CITY OF FORT LAUDERDALE

CASE COMMENT REPORT

CASE NO. UDP-S25007

CASE	UDP-S25007
PROJECT NAME	El Car Wash Coral Ridge
APPLICATION TYPE	Site Plan Level II
APPROVAL LEVEL	Development Review Committee (DRC)
REQUEST	Free Standing Automatic Car Wash
APPLICANT	5401 N. Federal Highway, LLC.
AGENT	Nectaria, M. Chakas, Lochrie & Chakas, P.A.
PROPERTY ADDRESS	5401 N. Federal Highway
ABBREVIATED LEGAL DESCRIPTION	CORAL RIDGE ADD B 41-47 B LOTS 18,19 & 20 BLK 12
ZONING DISTRICT	Boulevard Business (B-1)
LAND USE	Commercial
COMMISSION DISTRICT	1 – John Herbst
NEIGHBORHOOD ASSOCIATION	Knoll Ridge Homeowners Association
SUBMITTAL	March 7, 2025
COMPLETENESS ISSUED	March 14, 2025
EXPIRATION	July 11, 2025 (120 Days)
CASE PLANNER	Nancy Garcia Urban Planner II

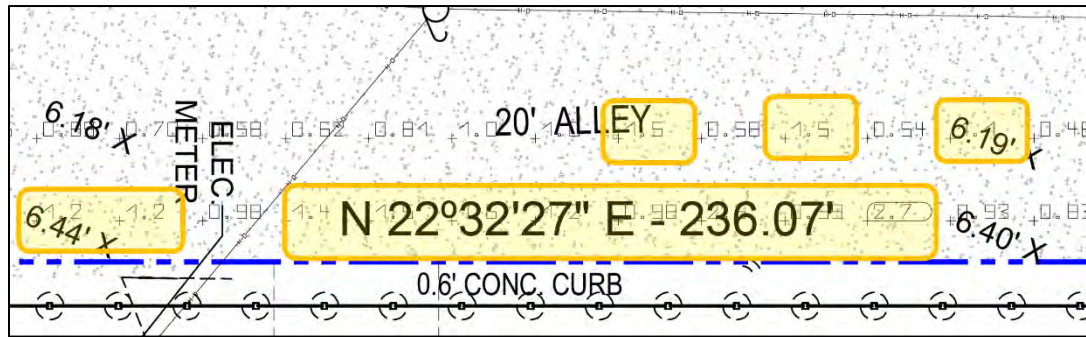
6. Pursuant to ULDR Section 47-25.3. - Neighborhood Compatibility Requirements, any non-residential operation or activity producing glare shall be conducted so that direct or indirect illumination of light shall not cause illumination in excess of one (1) footcandle on any abutting residential property. There are footcandle readings along the northern boundary that exceed one (1) footcandle. Also, the footcandle readings should be clearly labeled and not obstructed by the dimensions. See snippet of sheet EP-1 below.

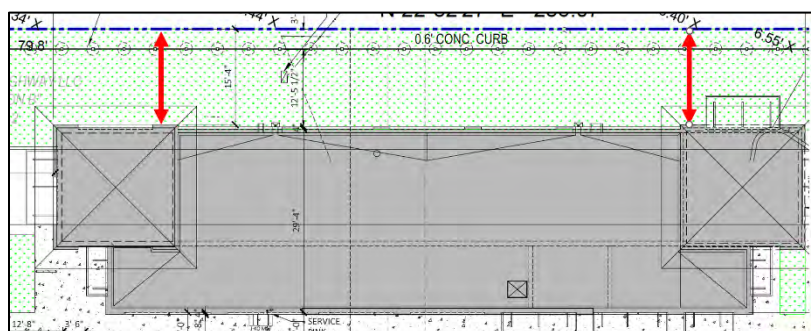
- b. The rear setback should be measured from the "towers", as this portion of the building protrudes out more than the main building. See snippet of sheet SP-1 below.

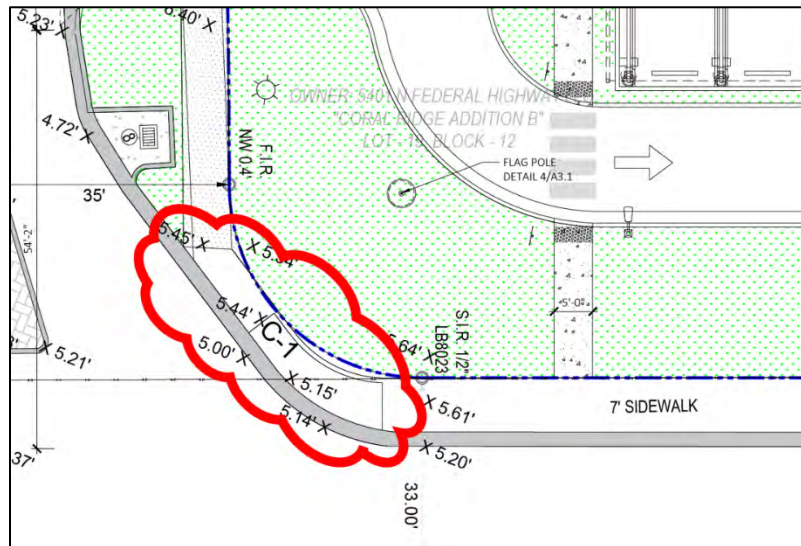
- c. The portion of the sidewalk at the corner of Federal Highway and NE 54th Street should be widened to match the width of the 7-foot sidewalk (see snippet of sheet SP-1 below).
